कार्यालय मुख्य वन संरक्षक, कुमाऊँ उत्तराखण्ड नैनीताल।

पत्रांक 3302 /12-1 दिनांक, नैनीताल 21/5/2025.

विषय:- जनपद- अल्मोड़ा के विधानसभा क्षेत्र जागेश्वर के अन्तर्गत लमगड़ा विकासखण्ड के ग्राम- तुलैड़ी से ग्राम पंचायत नैनी (जिफल्टा) कोकिलागांव तक मोटर मार्ग के निर्माण हेतु 3.60 है० वन भूमि का गैर वानिकी कार्यों हेतु लोक निर्माण विभाग को प्रत्यावर्तन के सम्बन्ध में प्रस्ताव सं० 151058/2022।

जनपद अल्मोड़ा में तुलैड़ी से कोकिलगढ़ तक लिंक मोटर मार्ग का निर्माण

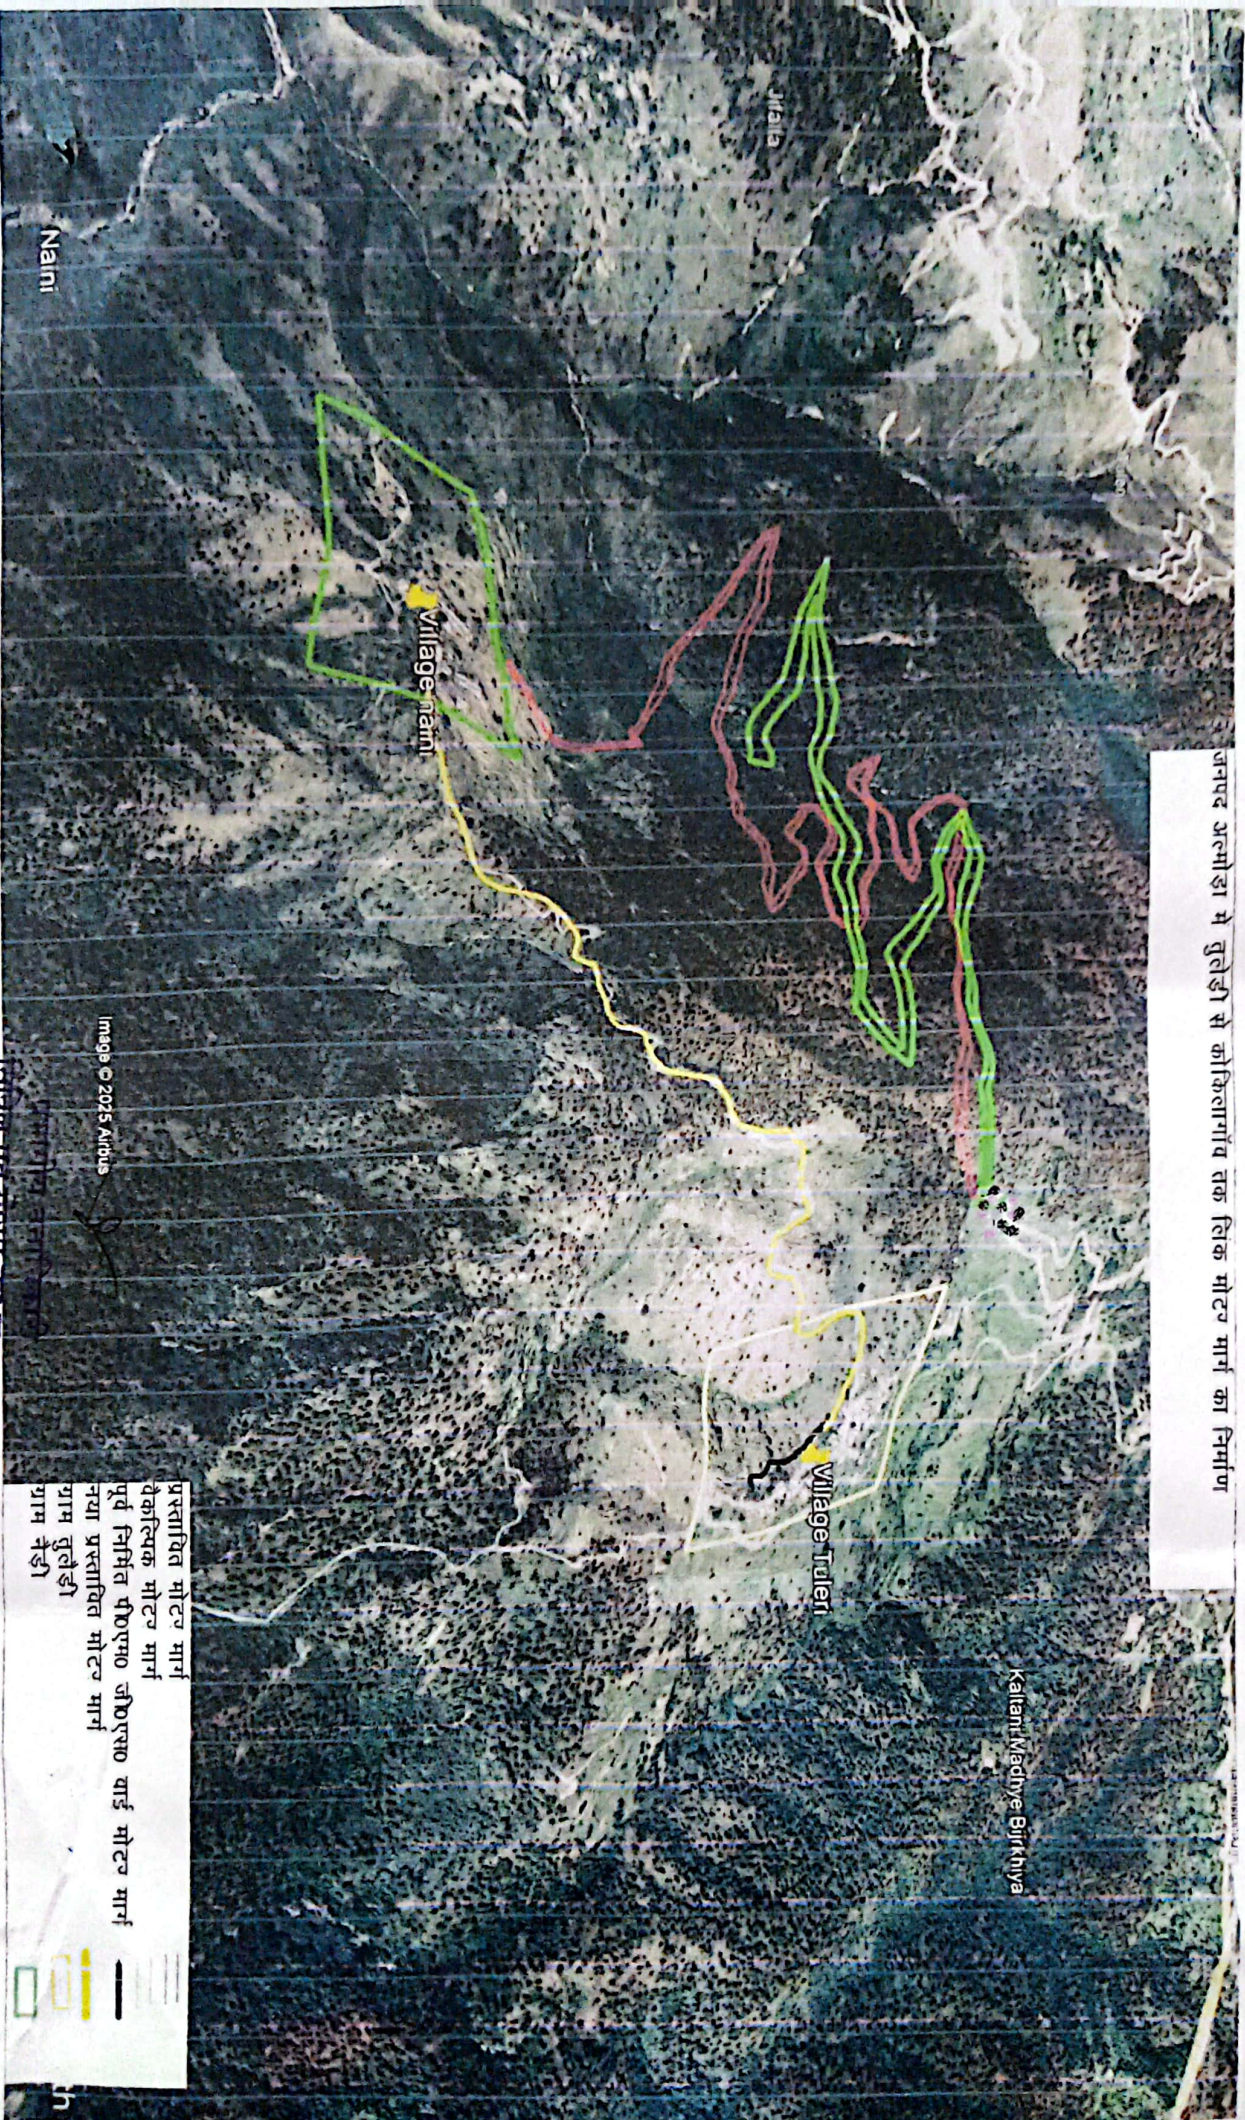
Furthermore, it is important to note that out of the two villages intended to be connected by this road, one village (Tuleri) is already connected through an existing PMGSY road. Upon review of the KML file and ground report, it is strongly recommended that the user agency reconsider the proposed alignment. Since Tuleri village is already connected by a PMGSY road, it would be more feasible to extend this existing road towards the second village (Naini). This alternative would primarily involve *nap* (private) land, a relatively gentler slope, and minimal tree felling.

For reference, a Google Map is attached herewith, which shows an existing trek route along which the user agency can propose a new alignment.
